APPLICATION NO.	FILING DATE	FIRST NAMED INVENTOR	ATTORNEY DOCKET NO.	CONFIRMATION NO.	
10/567,134	02/06/2006	Masahiko Igarashi	025416-00026	4553	
	ARENT FOX LLP 1050 CONNECTICUT AVENUE, N.W.			EXAMINER	
1050 CONNEC SUITE 400				GARCIA, ERNESTO	
	WASHINGTON, DC 20036		ART UNIT	PAPER NUMBER	
			3679		
			NOTIFICATION DATE	DELIVERY MODE	
			12/28/2009	ELECTRONIC

Application No.	Applicant(s)		
	10/567,134	IGARASHI ET AL.		
Office Action Summary	Examiner	Art Unit		
	ERNESTO GARCIA	3679		
The MAILING DATE of this communication a Period for Reply	appears on the cover sheet with	the correspondence address		
A SHORTENED STATUTORY PERIOD FOR REF WHICHEVER IS LONGER, FROM THE MAILING - Extensions of time may be available under the provisions of 37 CFR after SIX (6) MONTHS from the mailing date of this communication If NO period for reply is specified above, the maximum statutory perions - Failure to reply within the set or extended period for reply will, by state that the period for reply will, by state that the material patent term adjustment. See 37 CFR 1.704(b).	DATE OF THIS COMMUNICATION 1.136(a). In no event, however, may a report will apply and will expire SIX (6) MONTHULE, cause the a

Beigang, 6,142,033

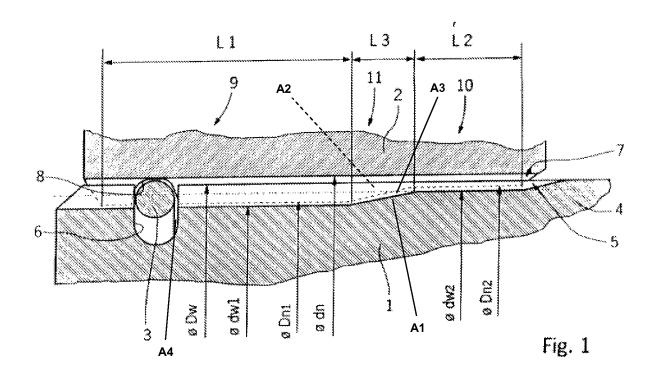
The indicated allowability of claim 1 is withdrawn in view of careful study of Beigang, 6,142,033, as the teeth are free to move due to a space between the teeth and another space between the ring 3 and annular groove 6 on the shaft. Rejections based on Beigang follow.

Regarding claim 1, as best understood, Beigang discloses, in Figure 1, a power transmission mechanism comprising a shaft 1 and a hub 2. A shaft tooth section is formed on the shaft and includes teeth. A hub tooth section is formed on the hub 2 and includes teeth. The hub 2 is disposed around the shaft 1 while holding the shaft tooth section and the hub tooth section in engagement with each other. The shaft tooth section has a crowned peak **Dw** having a tooth thickness along an axial length of the crowned peak and a shaft tooth valley. The hub tooth section has a peak **Dn1** and a hub tooth valley dn. The peak Dn1 of the hub tooth section opposes and engages the shaft tooth valley dw1, dw2 of the shaft tooth section. The peak Dn1 of the hub tooth section has a constant tooth thickness along an axial length. The hub tooth valley dn has a constant inside diameter in an axial direction of the shaft 1. The shaft tooth valley dw1, dw2 includes first and second portions having different outside diameters and connected by a first step region A1 (see marked-up attachment) sloping from a first starting point at an end of the first portion to an end of the second portion in a direction extending toward the hub tooth section. The peak of the hub tooth section includes first

and second peak portions having different inside diameters and connected by a second step region **A2** sloping from a second starting point at an end of the first peak portion to an end of the second peak portion in a direction extending away from the shaft tooth section.

Further, given that the teeth on the shaft and the hub are free to move relative to each other, the first step region and the second step region could be offset from each other in the axial direction since a gap A3 is present between the two step regions and another gap A4 allows a ring 3 to move freely with the hub, the shaft, or vice versa.

These gaps A3, A4 allows the hub to shift and thus making the step regions offset from each other. Therefore, it would have been obvious to one of ordinary skill in the art at

the time the invention was made to have the first step region be offset relative to the second step region in the axial direction due to these gaps being present.
